Service Bulletin Hi Fi Products

odel: D-151, D-151C, D-242CK, D-242SK, D-242CKT,

No. 525

Subject: No Sound Date: May 6, 1997

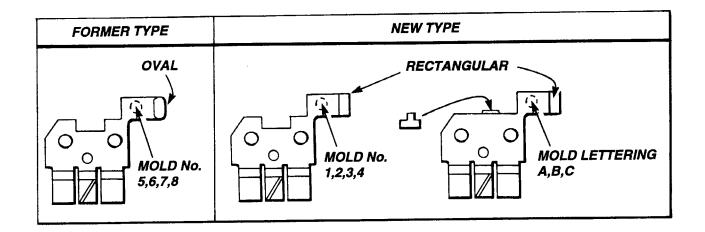
Solution: Verify Rack is damaged. If so, replace with improved version.

Note: The new version has the same part number as the old. Make sure to Look at the new piece and compare it to the diagram below.

DESCRIPTION	PART NUMBER
RACK	2-625-414-02
